CITY OF ISSAQUAH

SITE DEVELOPMENT PERMIT

FILE NO SDP16-00005

ISSAQUAH APARTMENTS
955 7th Avenue Northwest

Figure 3. Proposed street section for 7th Avenue NW (includes Shared Use Route)

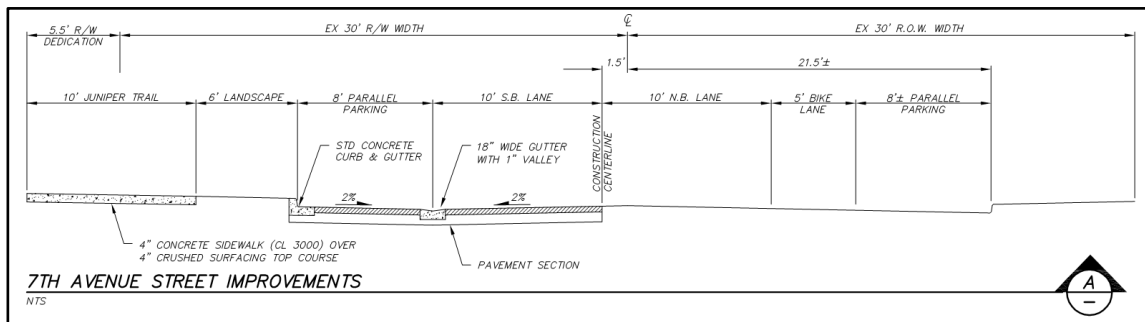
In order to implement the Core Street standards for the Issaquah Apartments street frontage and accommodate the existing Juniper Trail Shared Use Route in the new Core Street design, staff has interpreted the Core Street standards as it applies to this section of 7th Avenue NW, as follows:

Lanes	CIDDS	Modified Standards
Travel Lanes	2 @ 10' each	2 @ 10' each
Bicycle Lanes	2 @ 5' each (discretionary)	1 future 5' wide (east side) + 10' shared use route (west side)
Parking Lanes	2 @ 8'	2 @ 8'
Planter Type	Planter Strip or Tree Wells	Planter Strip
Landscape/Amenity Zone	6'	6'
Walkway Type	8' sidewalk	10' Shared Use Route (Juniper Trail)

Fig. 5. (Sheet A1.00) South driveway inconsistent with CIDDS 6.4.K

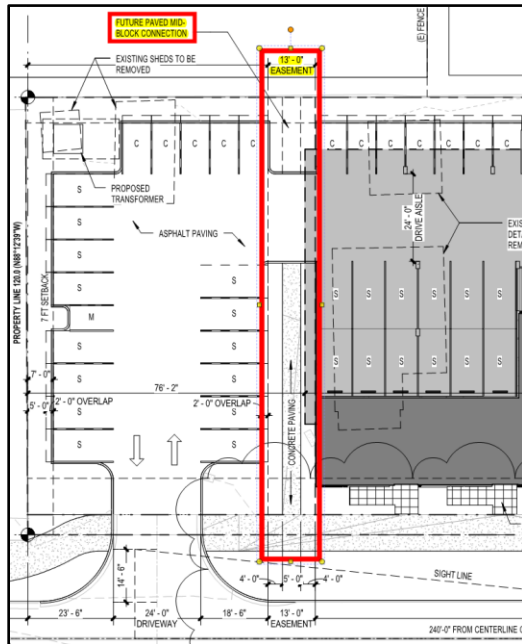
The south driveway as shown in Figure 5 (and on Sheet A1.00 of plan drawings) is not compliant with the Urban Driveway Standard as the sidewalk (Shared Use Route) does not continue through the driveway at a consistent grade and without any curb ramps. The Shared Use Trail must be constructed so that there is no break in grade so that the trail remains consistent across the driveway.

[Condition 5] *The Juniper Trail shall remain at a constant grade across the south driveway entry in accordance with Urban Driveway Standards – CIDDS 6.4.K.*

Figure 6. (left) Southern Pedestrian Connection Easement
Figure 7. (right) Northern Pedestrian Connection Easement

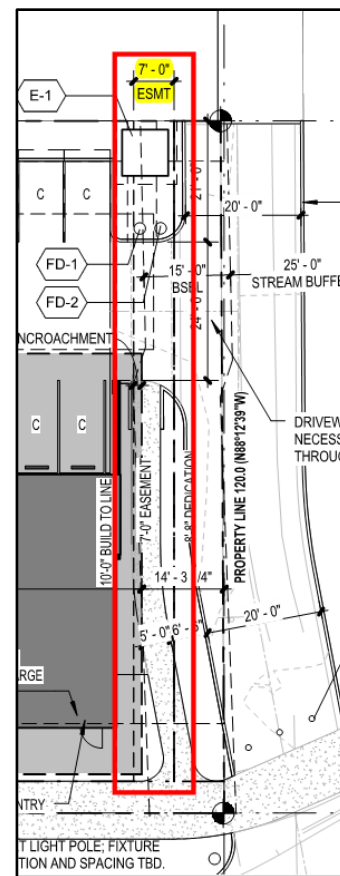
west would encroach into the private yards of the Aegis Issaquah community. However, a public pedestrian access easement shall be provided to allow for a continuation of the south pedestrian access to the building so that a viable through block connection is possible at a future date.

The applicant has proposed a second public pedestrian access easement at the north end of the site to allow for the future connection of the pedestrian walk that serves the primary entrance to the building. This easement would allow the walk to continue west toward and into the Aegis Issaquah community.

[Condition 6] *Prior to Temporary Certificate of Occupancy, public pedestrian access easements shall be granted to the City at the north and south ends of the building in order to provide future through-block points of connection for pedestrian access. The easements shall extend from the west property boundary to the east property boundary. The portions of the pedestrian crossings located within the parking lot shall be constructed with concrete or other similar materials to distinguish the pedestrian priority. If utility infrastructure is located within the easement area(s), it shall be sited, designed and constructed so that the pedestrian connections can be constructed in the future without having to be relocated or modified.*

Fig. 24 South elevation blank wall

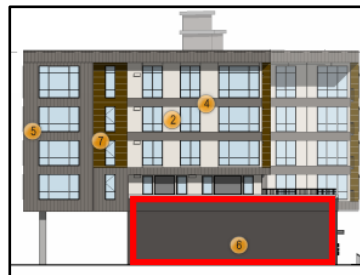
[Condition 15] *Blank wall treatment is required for the ground level brick walls located at the north and south building elevations and along the three brick and concrete walls which surround the ground level Community Space. Treatments include adding doors and windows, and/or using articulation or other techniques such as piers, modulation and detailing, and, applied elements.*
